**REPORT OF THE INFANTRY BOARD #1628, MODIFICATION OF TRIGGER SPRING,
CARBINE, CALIBER .30, M1 FORT BENNING, GEORGIA 10 JUNE 1944**

a. Standard Carbine Trigger Spring. b. Cavalry School Trigger Spring c. Ordnance Trigger Spring

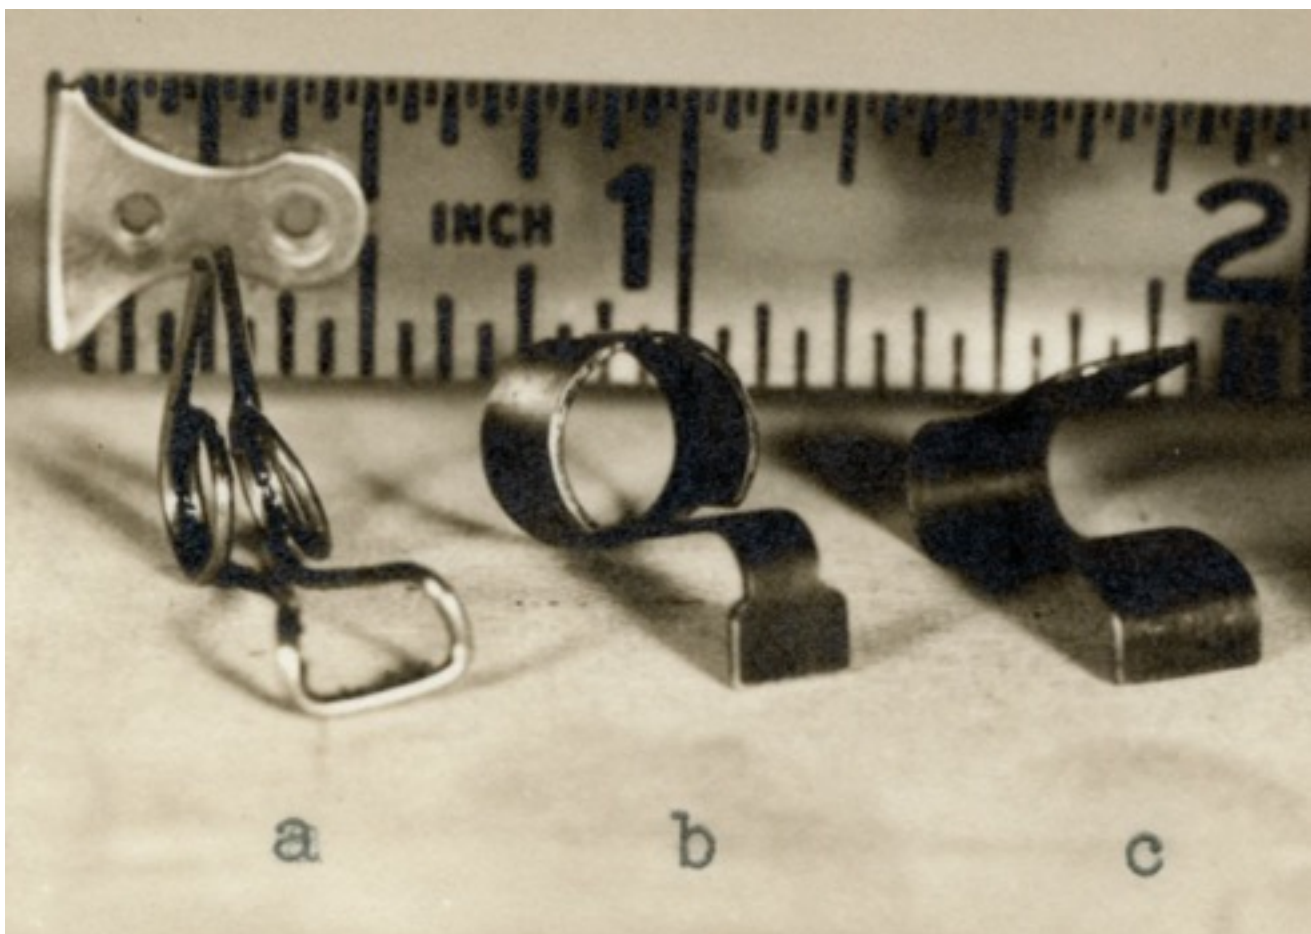
1. The subject trigger springs do not appreciably affect the trigger pull on the M1 Carbine and the M1 Carbine (Modified).
2. Neither of the subject springs is as rugged as the present standard spring.

3. None of the Cavalry type (Sgt. Brooks) trigger springs lasted through the abusive test. Four broke on the M1 Carbine after an average of 5800 trigger actuations, per spring, and four broke on the M1 Carbine (Modified) after an average of 3300 trigger actuations per spring.

4. One of the Ordnance springs lasted 44,031 actuations and the other 50,000 (only two were received for test).
5. The present standard springs operated efficiently during the test.

Recommendation: The Infantry Board recommends that the two types of subject springs be considered as unsatisfactory for purpose designed, and that no further consideration be given to their development."
